# WRITTEN REPRESENTATION FOR SPR EA1N and EA2 PROJECTS (DEADLINE 1)

**Interested Party:** SASSES    **PINS Refs:** 20024106 & 20024110

**Date:** 1 November 2020

## OPERATIONAL NOISE IMPACT

Figure 1

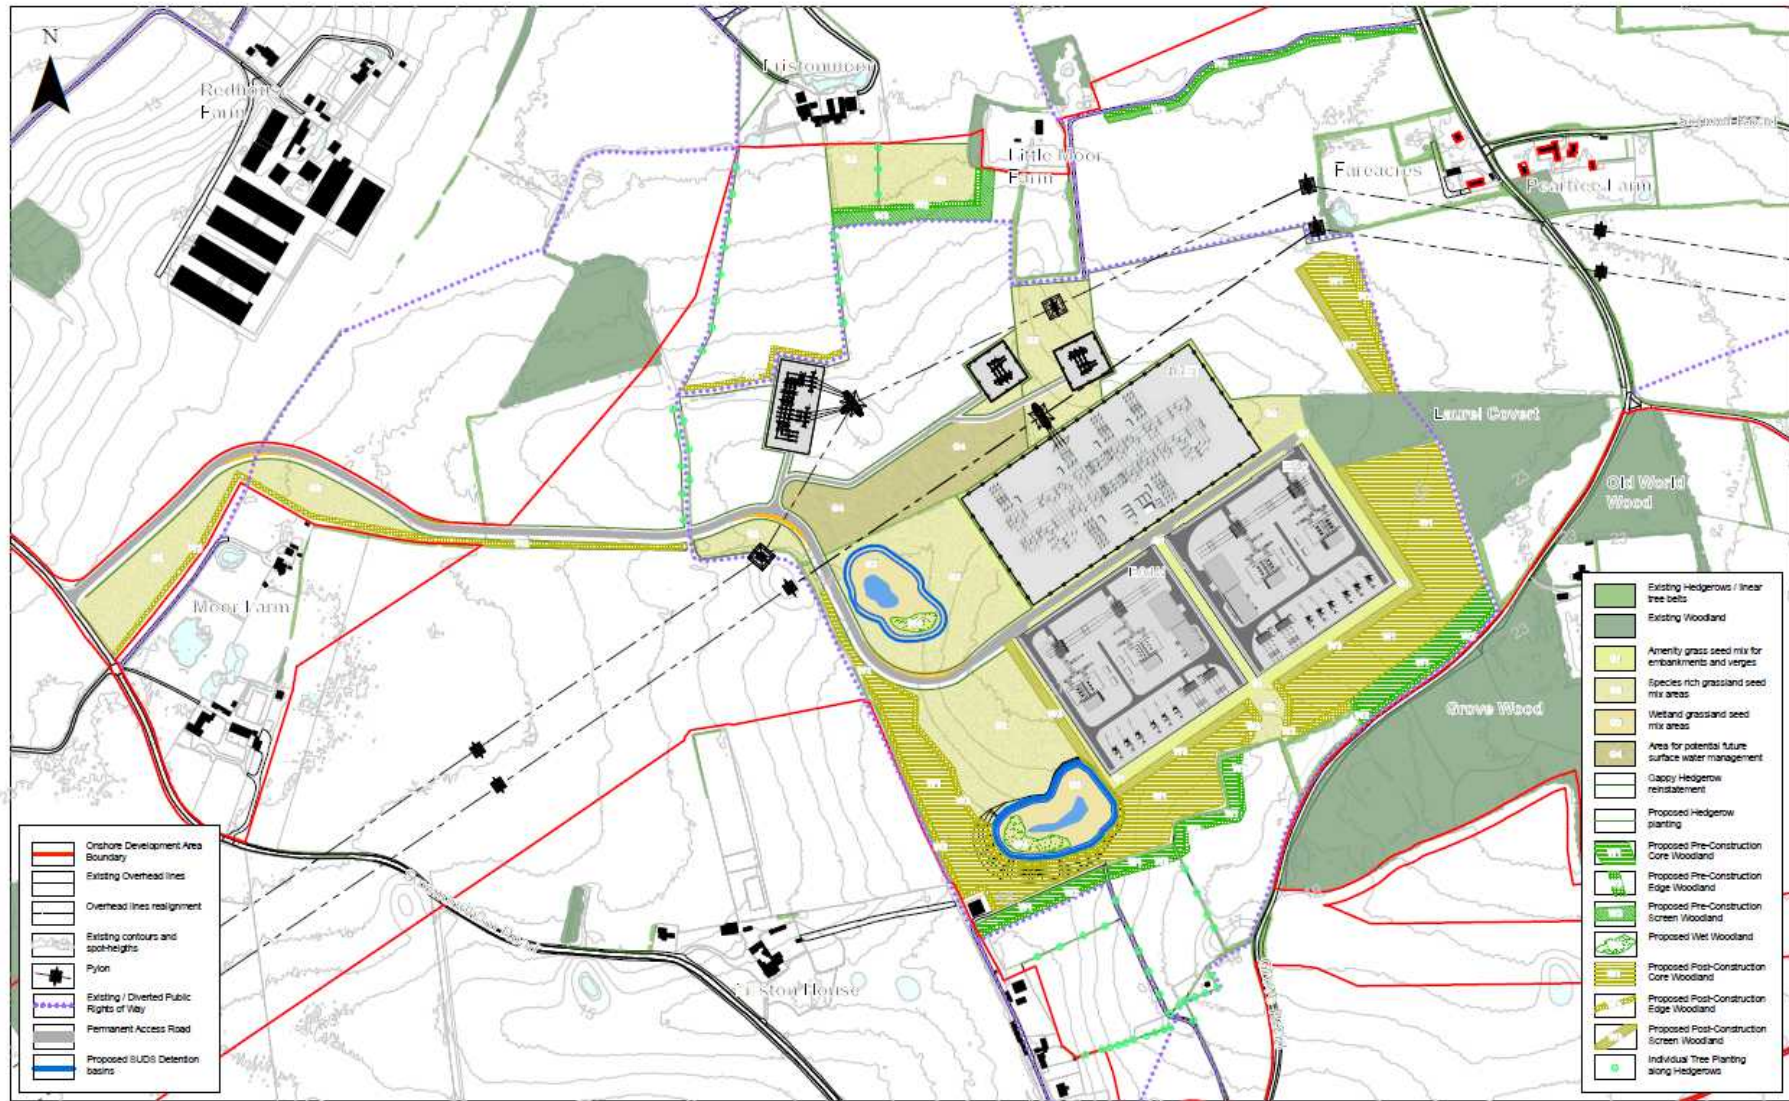
1. The project comprises 2 x 10 acre SPR substations, equipment up to 18m high + NGET substation (similar size) + multiple sealing end compounds and a new pylon all very close to a long-established village with a Grade 2\* parish church and graveyard, and some residential property within 250m of the substations themselves (Figure 1 below).
